SERVICE BULLETIN

SB1207

| COACH/BUS MODEL | : T and C coaches w/ Cummins engine |
| SUBJECT | : Turbocharger – compressor discharge elbow change |

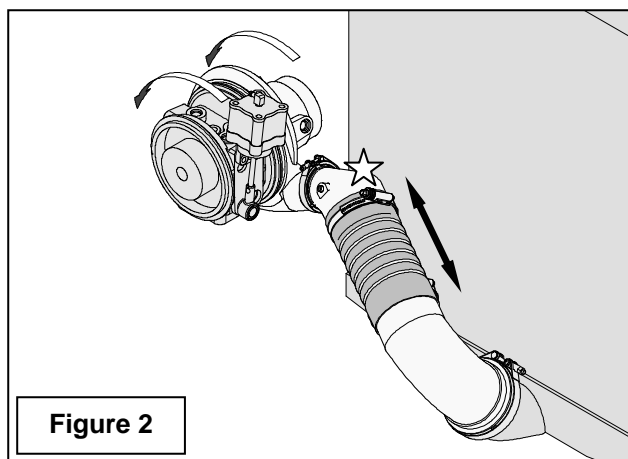
2. When the engine is under full load, thermal expansion can cause the clamps to stretch, resulting in a reduced clamping force on the housing mounting flanges.
If the clamping force is reduced to below the design clamping force, the discharge pressure can exert sufficient leverage on the discharge elbow to make the bearing housing and the compressor housing to which it is attached, rotate upward.
In severe cases the elbow may rub against the engine compartment closing panel, resulting in damage to the elbow (see Figure 2).

3. To address this issue, a new, shorter 135° discharge elbow now replaces the larger old 90° item. The new configuration considerably reduces the torque that the discharge pressure can apply to the turbo compressor and bearing housing assemblies.
The accompanying turbo compressor to charge air cooler piping has been adapted to suit.
4. A new closing panel, separating the engine compartment from the charge air cooler/battery compartment, has also been cut into production to suit the installation changes.
5. These product improvements have been cut into production as from units:
